SPRAG CLUTCH RETAINING RING

for CH210A, CH260A, CH290A, and PD21A hoists

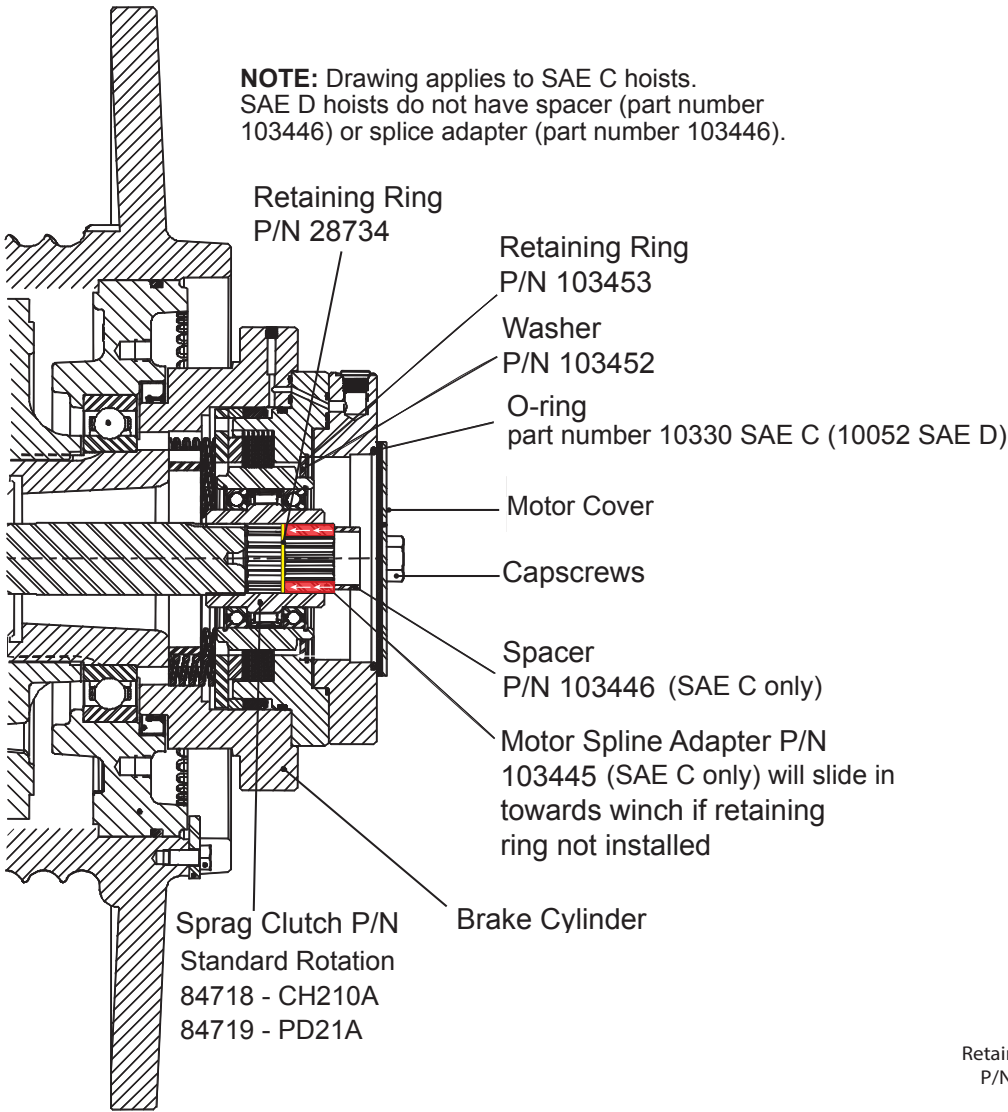
NOTE: Drawing applies to SAE C hoists.
 SAE D hoists do not have spacer (part number 103446) or splice adapter (part number 103445).

In models CH210, CH260A, and CH290A, the inner race rotates freely in the Counter-clockwise direction when viewed from the input side

In hoist model PD21A, the inner race rotates freely in the clockwise direction when viewed from the input side

Units with SAE C motors also have an SAE D to SAE C spline adapter (part number 103445) and a spacer (part number 103446). These two retaining rings, spline adapter, and spacer must be installed when servicing the hoist.
